# UNITED STATES PATENT AND TRADEMARK OFFICE

APPLICATION NO.	FILING DATE	FIRST NAMED INVENTOR	ATTORNEY DOCKET NO.	CONFIRMATION NO.
10/051,602	01/17/2002	William A. Baker	5893.02	1121

**Office Action Summary**

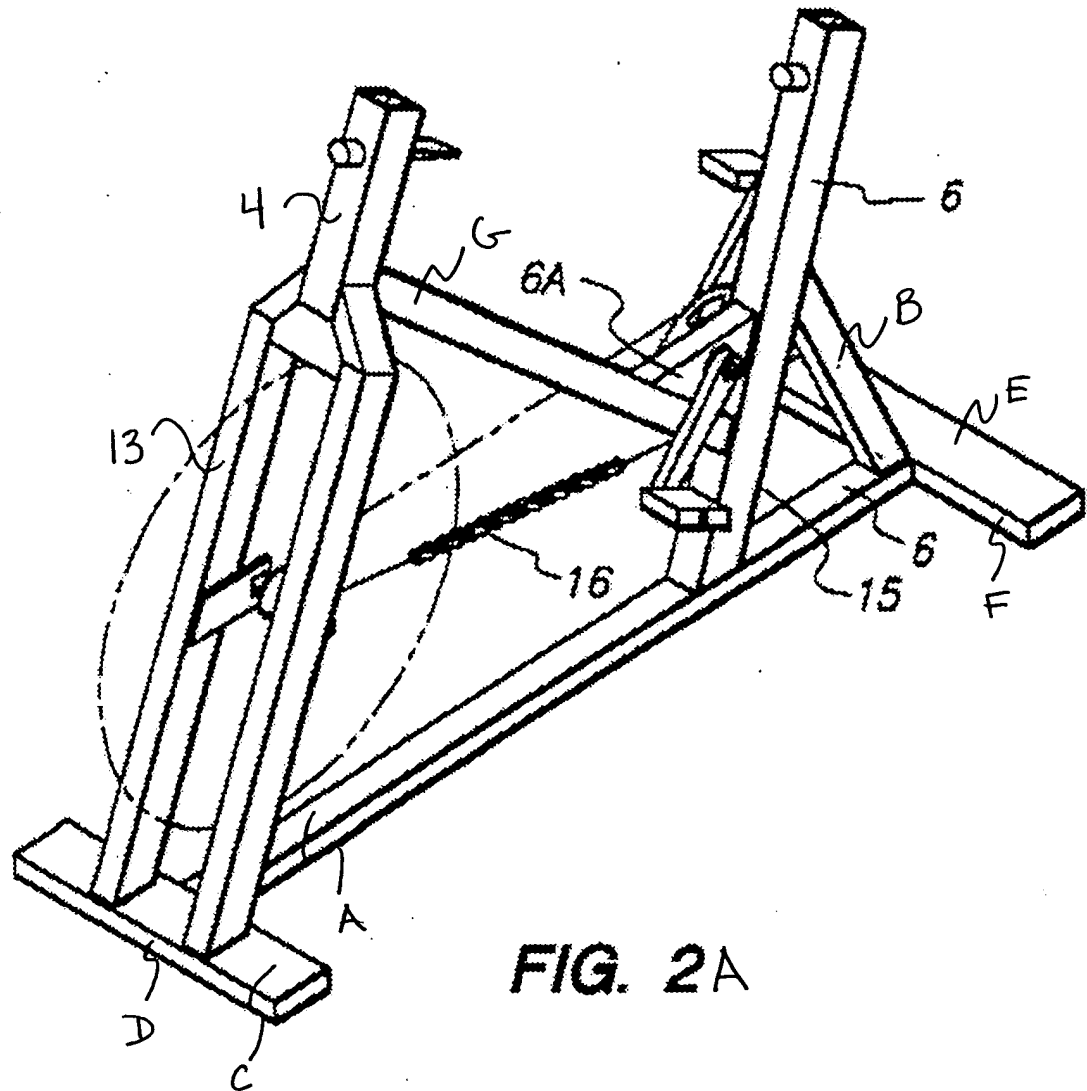
2. As to claim 1, Goldberg discloses a frame comprising an upper front end (4), a lower front end (A), a rear end (B) and a set of forks (13) wherein the upper front end is attached to the forks and the lower front end is in a fixed position relative to the forks (see Fig. 2A below). Goldberg does not disclose that the frame is of a monoframe/monocoque construction. Bowden discloses an exercise bicycle having a frame of monocoque construction wherein the skin of the frame carries a major part of the stresses applied to the frame (see Figs. 1, 2 & 11 and Col. 1, lines 41-46). At the time of the invention, it would have been obvious to a person of ordinary skill in the art to make Goldberg's frame from semi-monocoque components since monocoque frames

3. As to claims 2, 3, 8 and 9, Goldberg and Bowden disclose a modified frame as described above (see discussion of claim 1). Goldberg further discloses that the upper front end is attached to the forks and the lower front end is in a fixed position relative to the forks as substantially claimed. The monoframe's lower front end and the fork's bottom end are attached to a first plate (C), the first plate is supported on a front base (D), the rear portion of the monoframe is attached to a second plate (E) that is supported on a rear base (F). Additionally, the monoframe has a shape defined by a central body and a first extension therefrom defined by said monoframe and a top tube (G) (see Fig. 2).

Fig. 1B

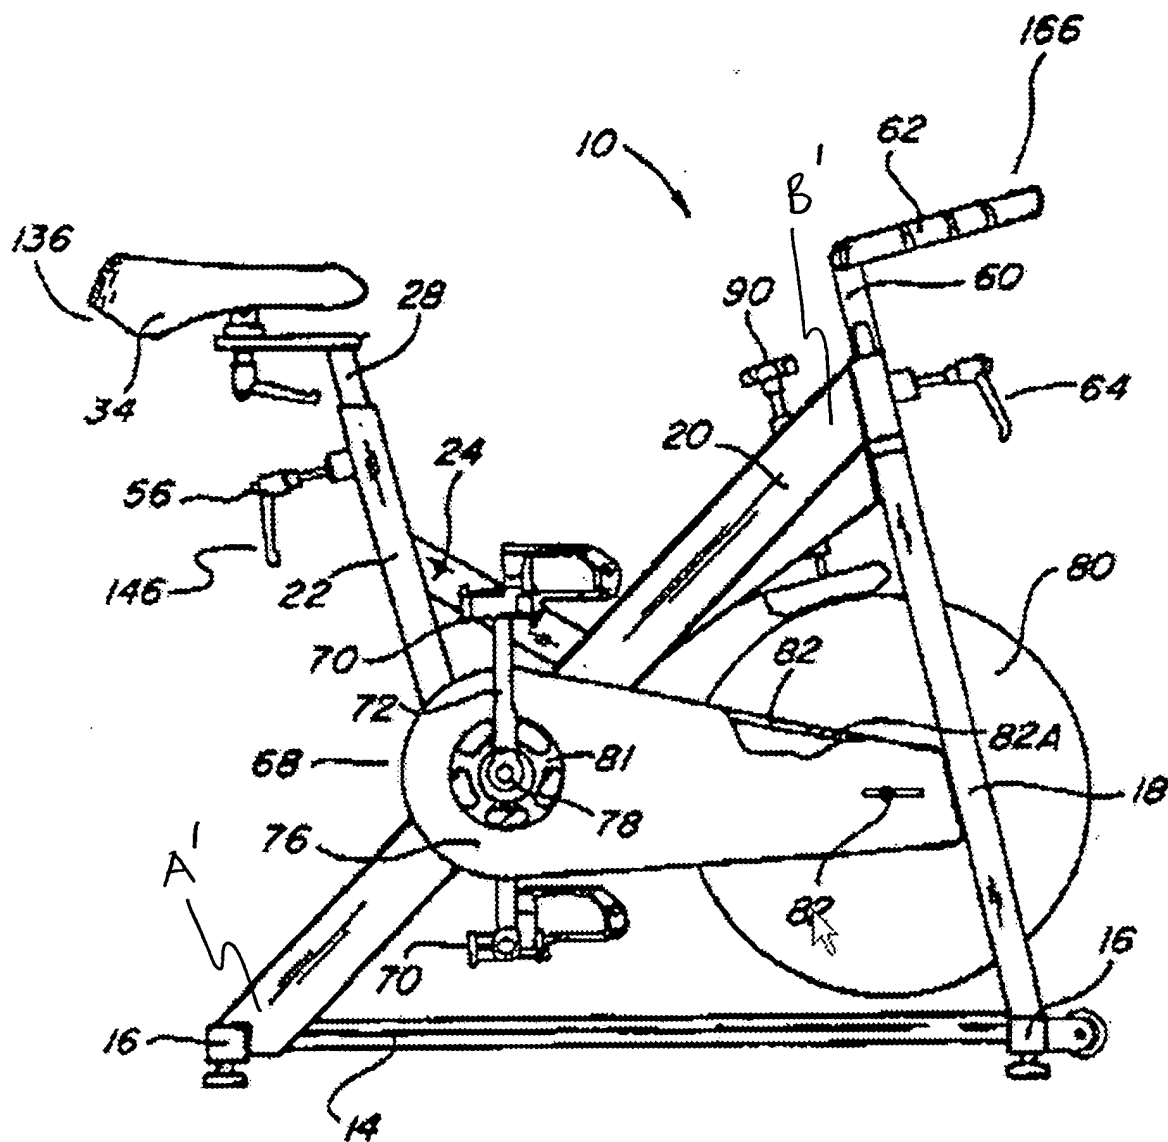
6. As to claim 10, Forcillo discloses a frame for an exercise bicycle comprising a frame comprising a rear support (A'), a top support (B'), a seat support (22) and a seat tube (28) partially received within the seat support (see Fig. 1B below). Forcillo does not disclose that the frame is of a monocoque construction. Bowden discloses an exercise bicycle having a frame of monocoque construction (see Figs. 1, 2 & 11 and Col. 1, lines 41-46). At the time of the invention, it would have been obvious to a person of ordinary skill in the art to make Forcillo's frame from semimonocoque components since a monocoque frame is relatively lighter than a traditional frame while providing functionally equivalent support and resistance to compression and shear forces. Forcillo does not disclose a bottom tube connected to the seat tube at a connection point wherein the frame member encloses the connection point. Huang discloses a bicycle frame having a seat support and adjustment means that include a seat tube (30) at least partially received within a seat support (11, C') and a bottom tube (20) connected to the seat tube at a connection point (D') wherein the frame member encloses the connection point (see Figs. 1C & 2C below). At the time of the invention, it would have been obvious to a person of ordinary skill in the art to substitute Forcillo's seat support and adjustment means (28, 146) with Huang's seat support and adjustment means since they are functionally equivalent in providing a stable support and quick height adjustments to the seat.

8. As to claims 16 and 17, Forcillo, Bowden and Huang disclose a modified frame as described above (see discussion of claim 11). Forcillo further discloses a bottom support (14) extending forward from a rear support and a front fork assembly (18) that is connected with the bottom support (14) and a top support (B') (see Fig. 1B above).

11. As to claims 29 and 30, Forcillo, Bowden, Huang and Harris disclose a modified frame as described above (see discussion of claim 28). Forcillo further discloses that the frame panels each include an aperture for receiving a bottom bracket (78) that is connected with the seat tube wherein the bracket is configured to support a drive train (see Fig. 1B above).

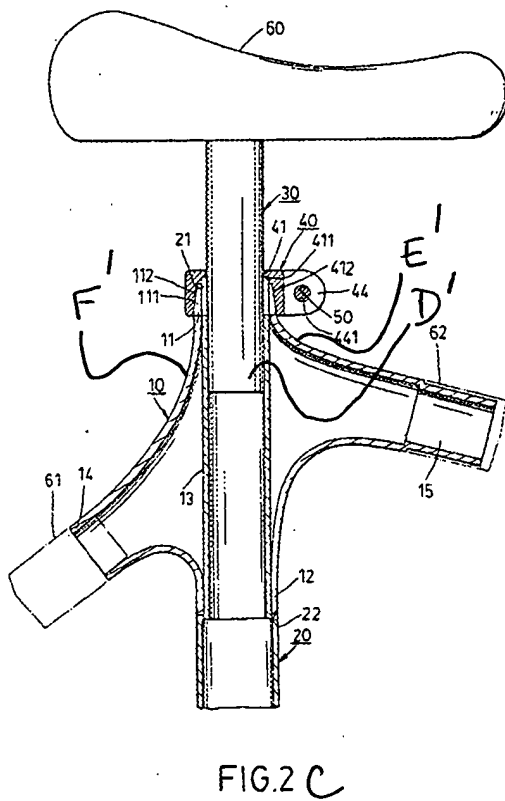
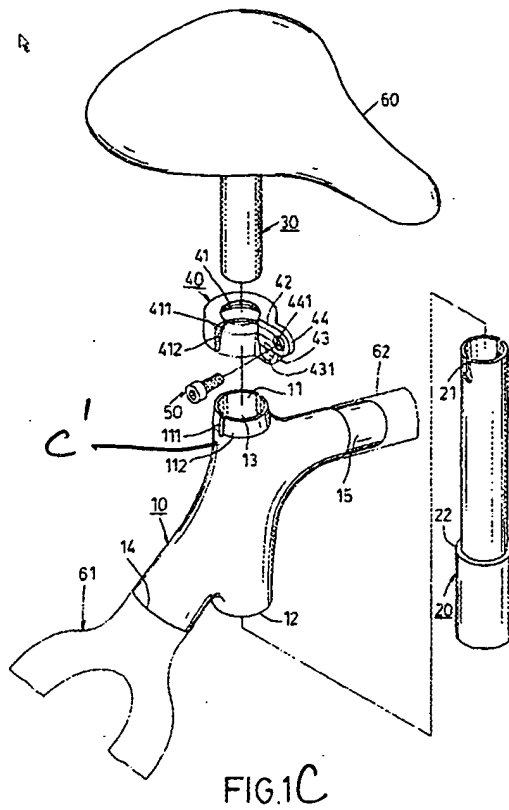
9. As to claims 24-27, Forcillo, Bowden and Huang disclose a modified frame as described above (see discussion of claim 11). Forcillo discloses a seat support (22) but he does not disclose that the seat support defines a rear concave wall and a front concave wall as substantially claimed (see Fig. 1B). Huang discloses a seat support (11, C') that defines a front concave wall (E') and a rear concave wall (F') as substantially claimed (see Fig. 2C). At the time of the invention, it would have been obvious to a person of ordinary skill in the art to make Forcillo's seat support (near it's lower end) define a rear concave wall and a front concave wall to provide a reinforced area for the frame to receive the seat tube. Furthermore, a change in the shape of a

**FIG. 2D**

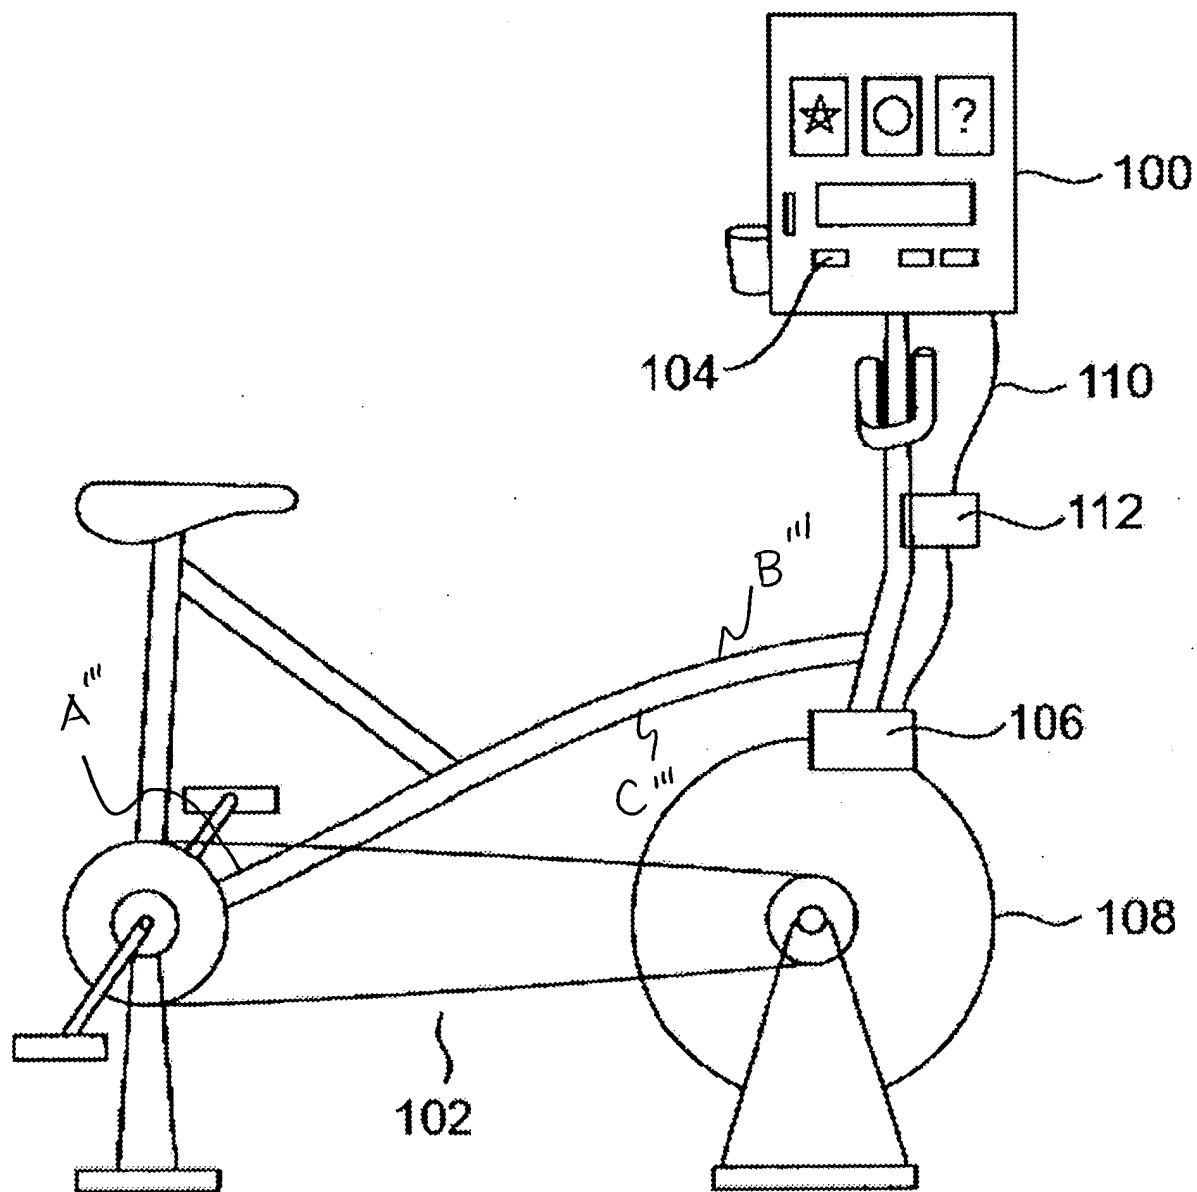
12. As to claims 12, 13, 18, 19, 31 and 32, Forcillo, Bowden and Huang disclose a modified frame as described above (see discussion of claims 10 and 16). Forcillo does not disclose that the rear, top and bottom supports define an upper convex wall and a lower convex wall such that the lower concave surface of the top support intersects the top concave surface of the bottom support. Harris et al. disclose an exercise device having a frame that includes an upper convex wall (B''') and a lower concave wall (C''') (see Fig. 2D below). At the time of the invention, it would have been obvious to a person of ordinary skill in the art to make Forcillo's rear, top and bottom supports to have concave and convex characteristics since those characteristics are known in the exercise art and Forcillo and Harris' shaped components are functionally equivalent in providing a rigid support. Furthermore, a change in the shape of a prior art device is a design consideration within the skill of the art. *In re Dailey*, 357 F.2d 669, 149 USPQ (CCPA 1966).

FIG. 1E

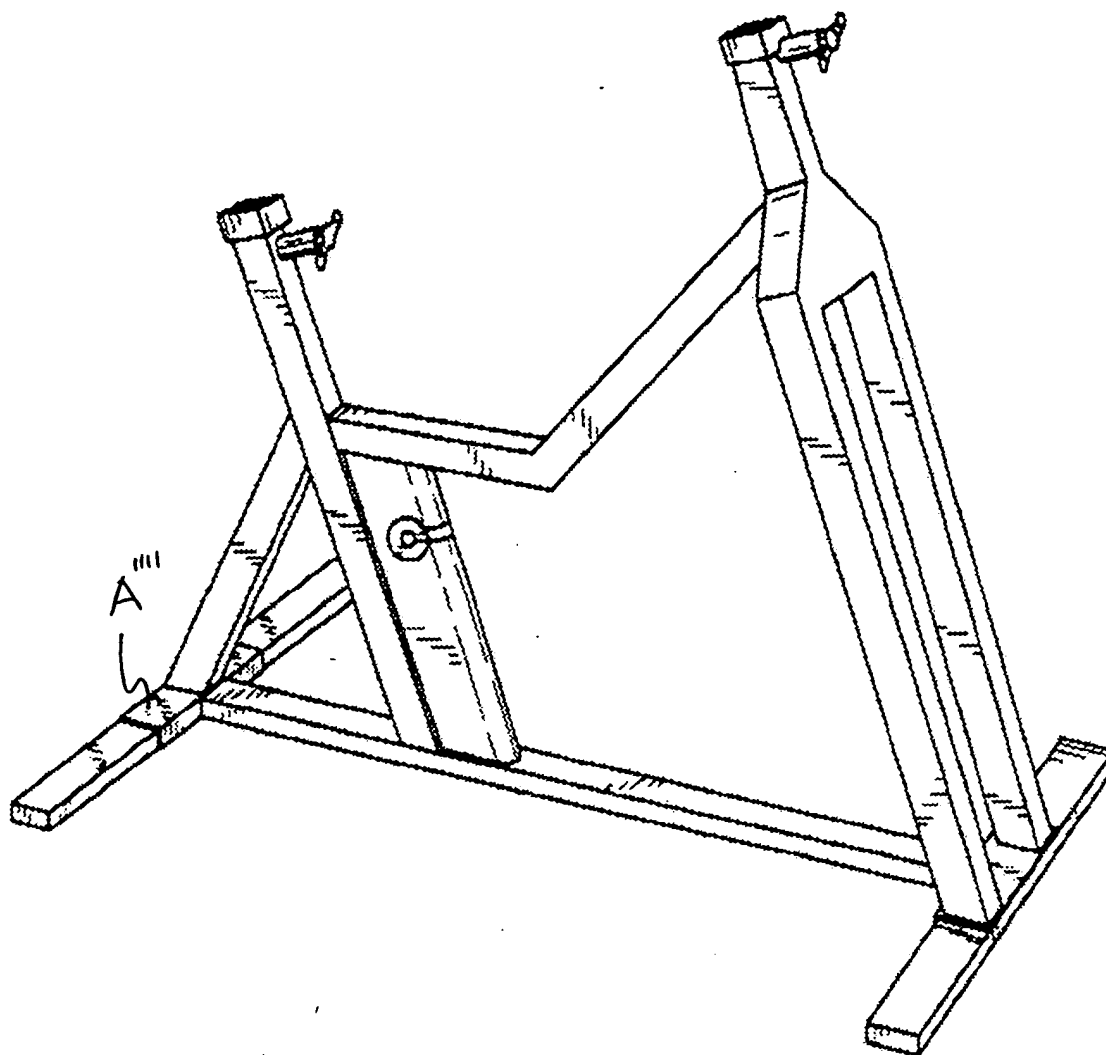
13. As to claims 14 and 15, Forcillo, Bowden, Huang and Harris disclose a modified frame as described above (see discussion of claim 13). Forcillo does not disclose a frame that includes a rear plate as substantially claimed. Luull et al. disclose an exercise device having a frame that includes a rear plate (A''') extending transversely from the rear support to laterally support the frame wherein the plate is attached to both the lower concave wall and the upper convex wall (see Fig. 1E below). At the time of the invention, it would have been obvious to a person of ordinary skill in the art to add such a plate to Forcillo's frame to provide a more stable connection between the frame and transverse foot supports.
